# SITE CERTIFICATION APPLICATION

## Sufficiency Responses

### Cane Island Power Park

RE: Kissimmee Utility Authority-Florida Municipal Power Agency  
Site Certification Application - Cane Island Power Park  
DOAH Case No. 98-3619 EPP  
DEP Case No. 98-2297  
Response to Statement of Sufficiency

SECTION 3  
NO SCALE  
SEE DWG S3001

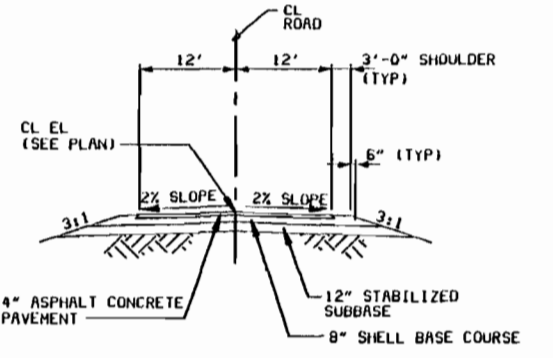
26. *Provide cross-sections of the percolation and detention ponds.*

**Response:** The percolation pond cross-section is provided as Section 3 of Drawing 59140-CSTF-S3011 included in Attachment E to this sufficiency response package. The detention pond cross-section is included as Section 5 - Wet Detention Basin Section on Figure 3.8-2 of the SCA.

PROJECT: 59140-3STF-S3010  
DATE: 11-02-98  
FIGURE 3.8-2

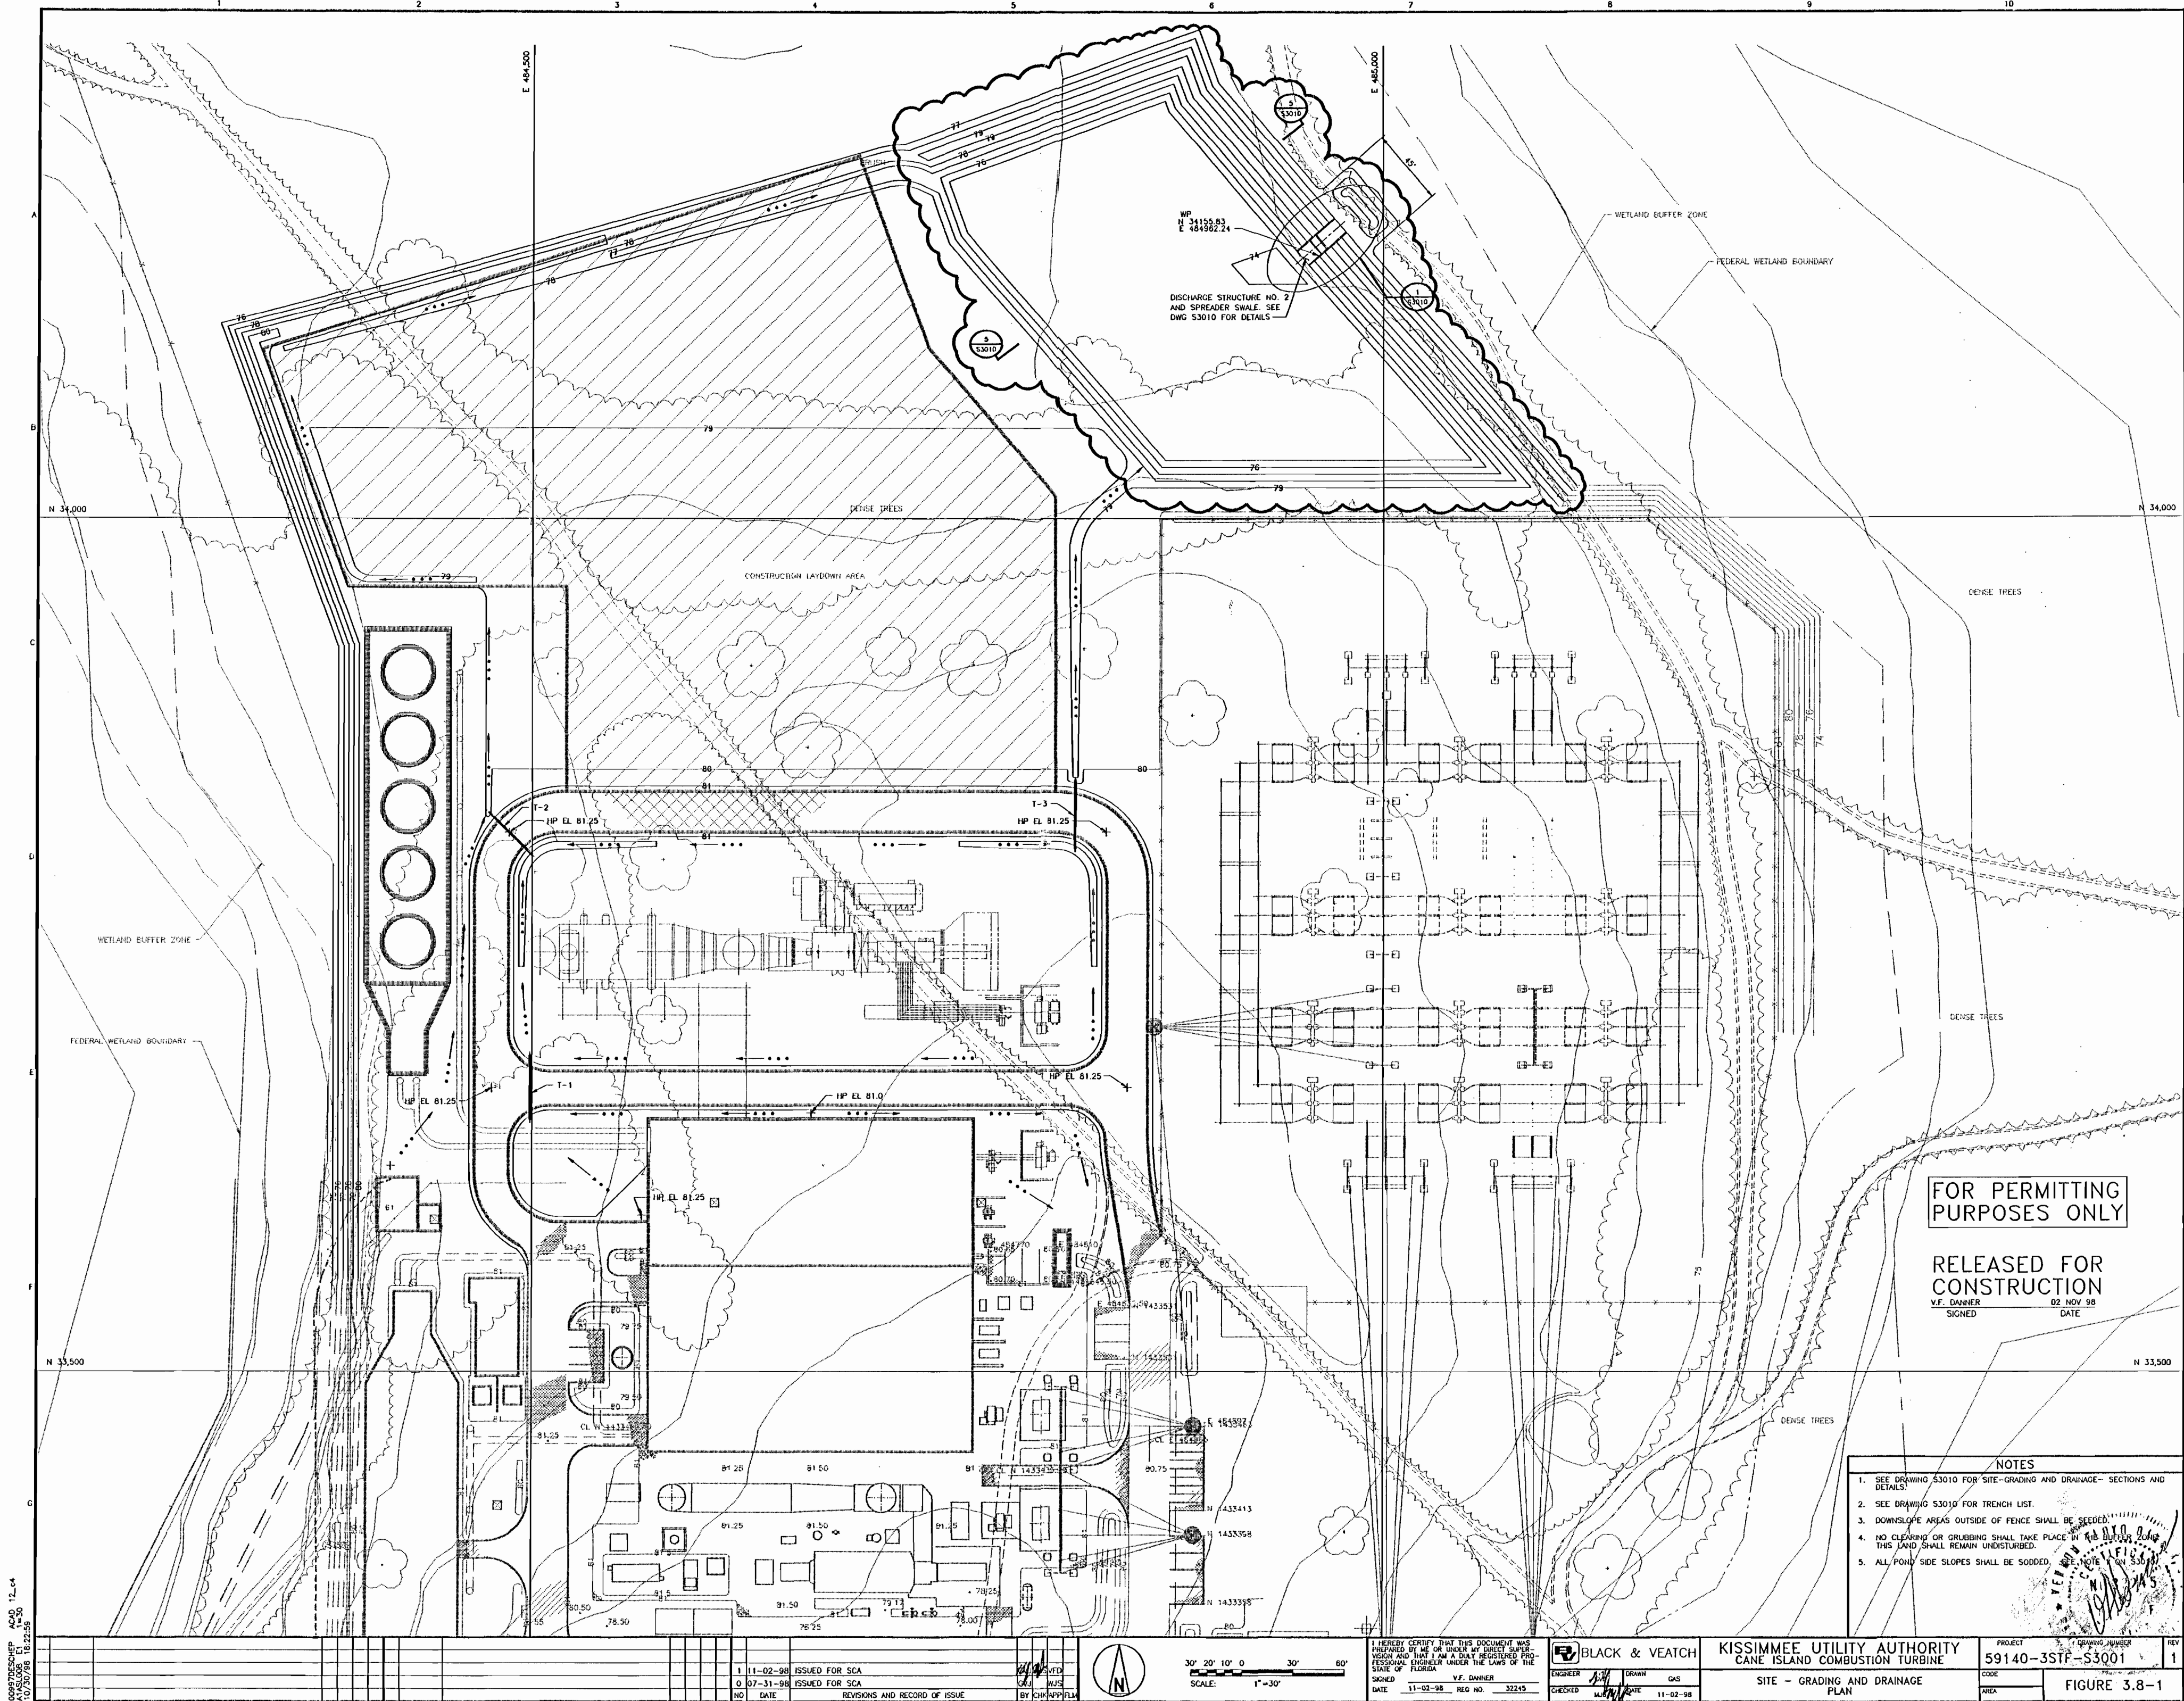
1. *Straw bale dikes are rarely installed correctly and less frequently maintained;*
2. *Straw bale dikes are very labor-intensive and require frequent replacement;*
3. *An exotic and invasive species called the tropical soda apple is associated with straw bales and has potential to adversely affect the ecosystem; and*
4. *Straw bale dikes are more expensive than silt fencing; Straw bale dikes cost approximately \$4 per foot while silt fencing costs less than \$2 per foot.*

**Response:** Straw bale dikes have been deleted from the SCA and Figure 3.8-2 of the SCA. The silt fence detail and notes have been updated to meet the double row recommendation, and is included in Attachment E.

Figure 6.1-1

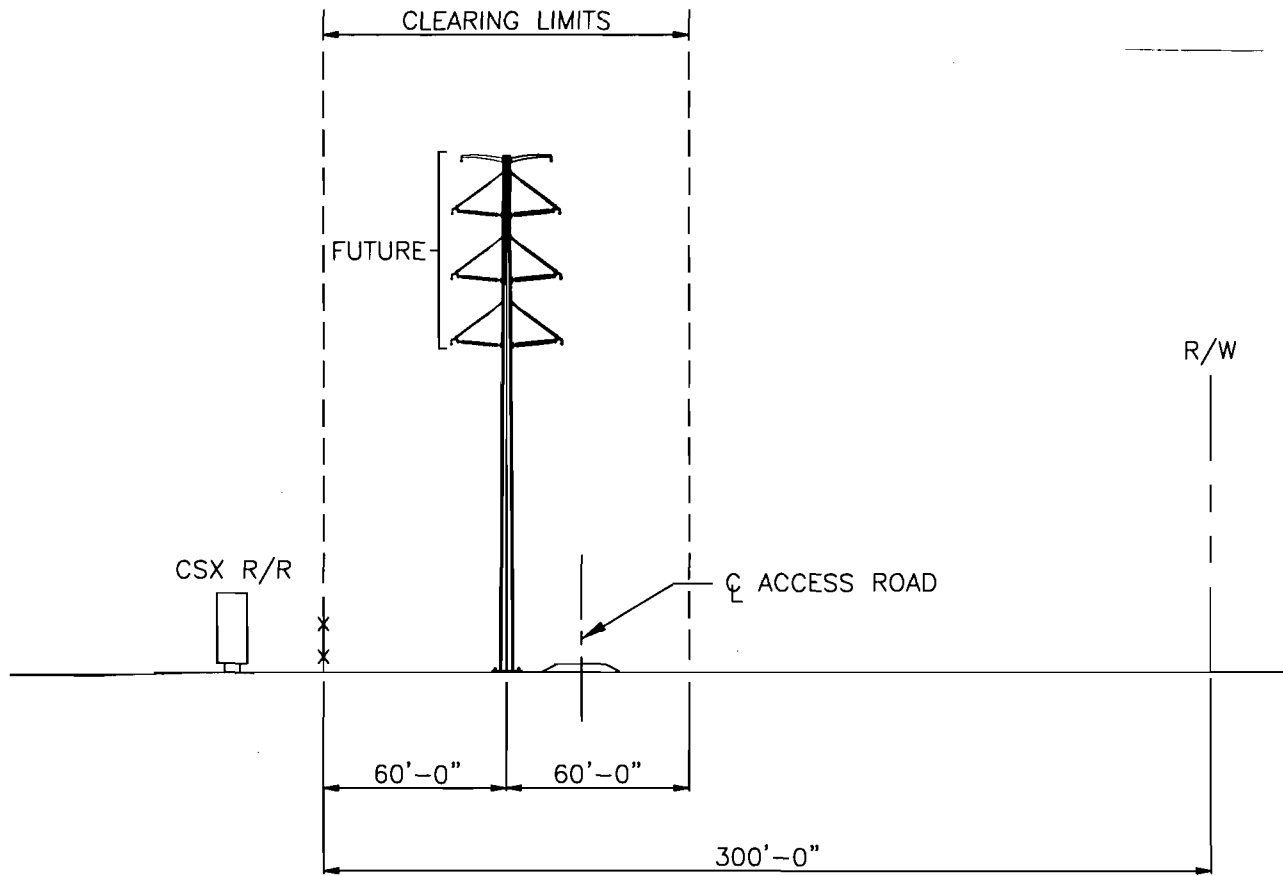
30. *The proposed power transmission line system required for the Cane Island Plant will impact a total of 19.7 acres of wetland (section 6.0). Table 6.1-2 provides a very basic breakdown of the impacts but does not provide the location indicating where these impacts will be located. In addition there is no discussion of alternative corridors which may reduce wetland impacts, nor is mitigation for the destruction of the wetlands discussed.*

31b. *In section 6.0, (transmission lines), it is stated that access roads will be required through the wetland areas and that fill will be placed and culverts may be utilized. Figure 6. 1 -1 is identified as showing the location of the proposed fill locations, unfortunately Figure 6. 1-1 is a blank page. If fill is used to construct access roads and culverts are not utilized, how will surface water flows be maintained? Will the project result in flooding to adjacent areas? If culverts are to be utilized, where will they be placed and will they maintain historic water flow patterns.*

*Please furnish a revised legend that provides this information.*

**Response:** The proposed power transmission line system required for the Cane Island Plant will impact a total of 11.3 acres of wetlands (section 6.0). The revised Figure 6.1-1 enclosed as Attachment F indicates wetlands impact areas. Attachment F also includes signed/sealed transmission line construction drawings. Two other routes options were evaluated (Figure 6.1-1); however, these routes would result in greater impacts because of potentially longer line lengths, and additional vegetation clearing and construction within wetland areas. The proposed mitigation plan for the impacts to wetlands in the transmission line corridor is included as Attachment G.

**Response:** The map was printed incorrectly and some information was not as clear as it should have been. The revised Figure 6.1-1 is enclosed as Attachment F.
